Mitigation Plan  
Banner Branch Mitigation Project  
Stokes County, North Carolina  
FINAL VERSION

NCDEQ DMS Project Identification # 100080  
NCDEQ DMS Contract # 7610 and # 7701  
Roanoke River Basin (Cataloging Unit 03010103)  
USACE Action ID Number: SAW-2018-01760  
Contracted Under RFP # 16-007405  
DWR Project # 20181154

Re: NCIRT Review and USACE Approval of the NCDMS Banner Branch Mitigation Site /  
Stokes Co./ SAW-2018-01760/ NCDMS Project # 100080

**SUBJECT:** Banner Branch Mitigation Site - NCIRT Comments during 30-day Mitigation Plan Review

**22**

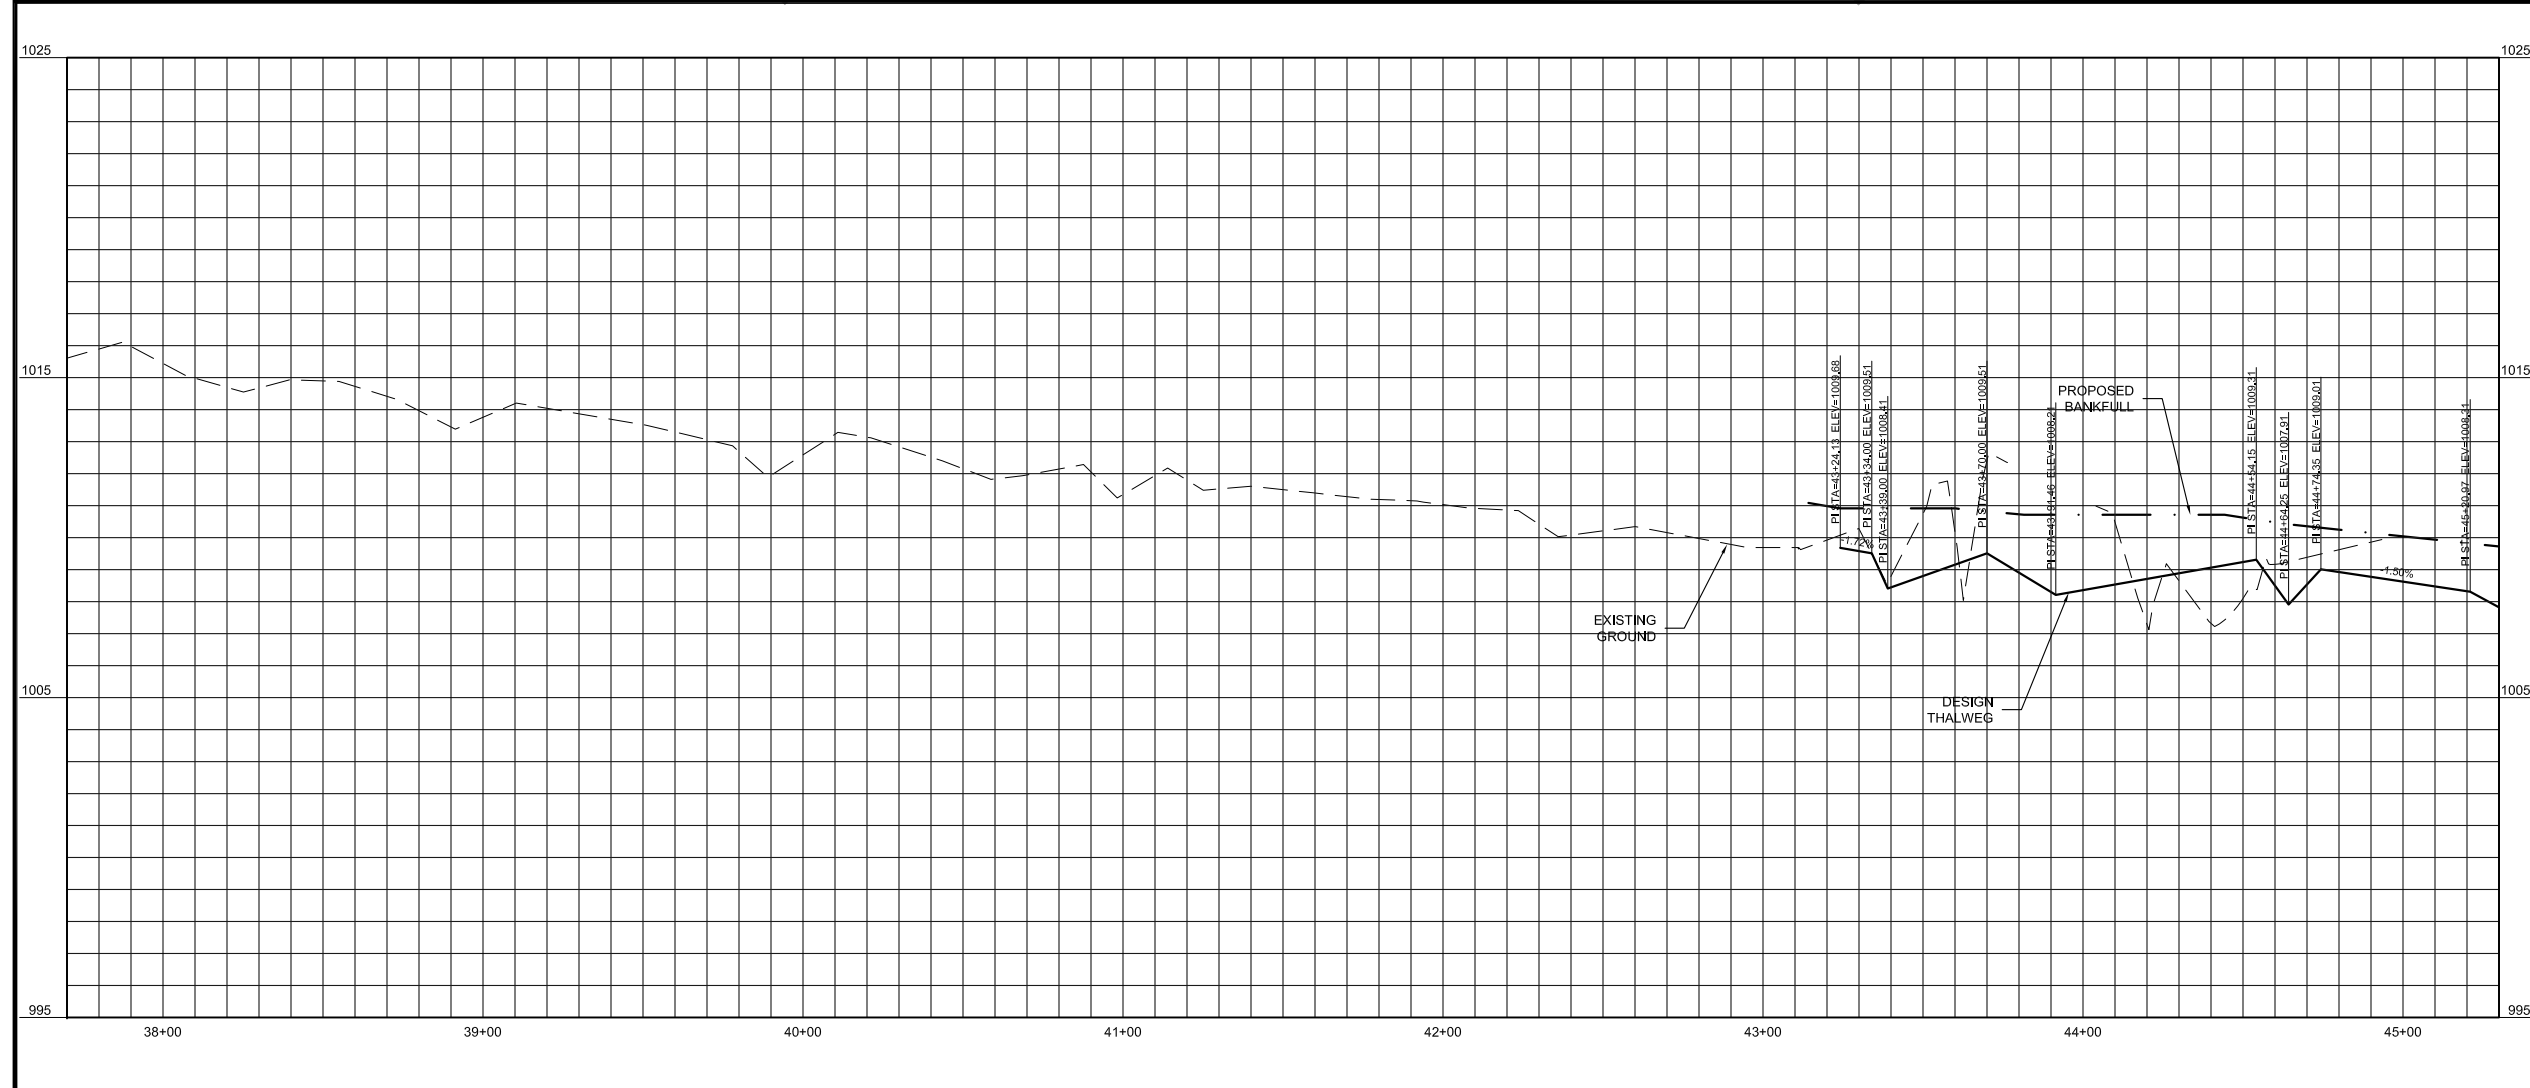
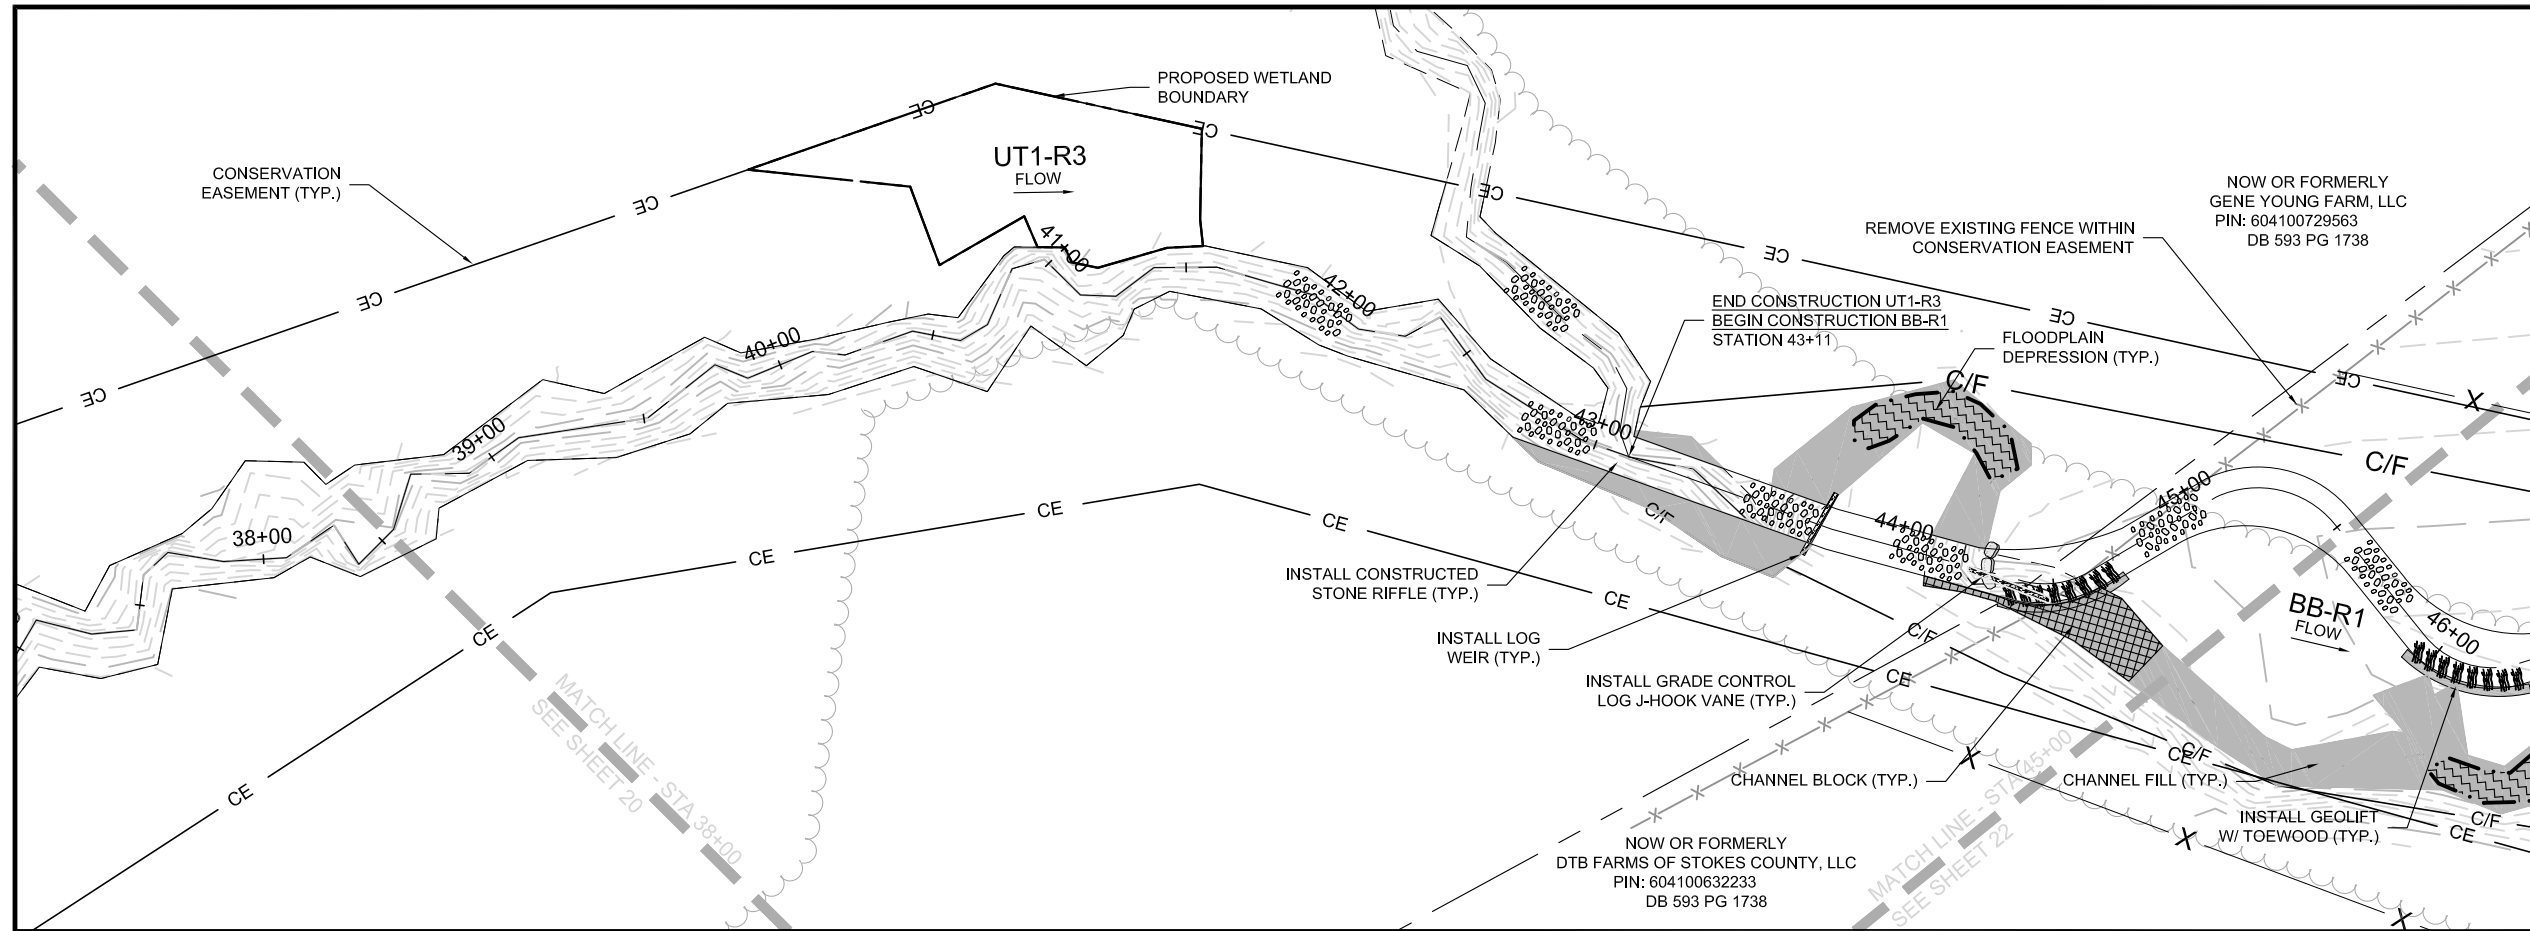
26. Sheet 22 – The tributary connecting with UT1-R3 at Station 43+00 is not mentioned anywhere in the plan. Since a section of this trib. it is located within the project site and may be potential sediment source for BB-R1, please include a brief description of the channel condition.

**26. Sheet 22 - The tributary connecting with UT1-R3 at Station 43+00 is not mentioned anywhere in the plan. Since a section of this trib. is located within the project site and may be potential sediment source for BB-R1, please include a brief description of the channel condition.** Response: The tributary shown on sheet 22 is Banner Branch which flows from the east and connects with UT1-R3 near Station 43+00. We have added language to the existing reach condition summary in Section 3.4.1, pg 24 that briefly describes the upstream channel condition.
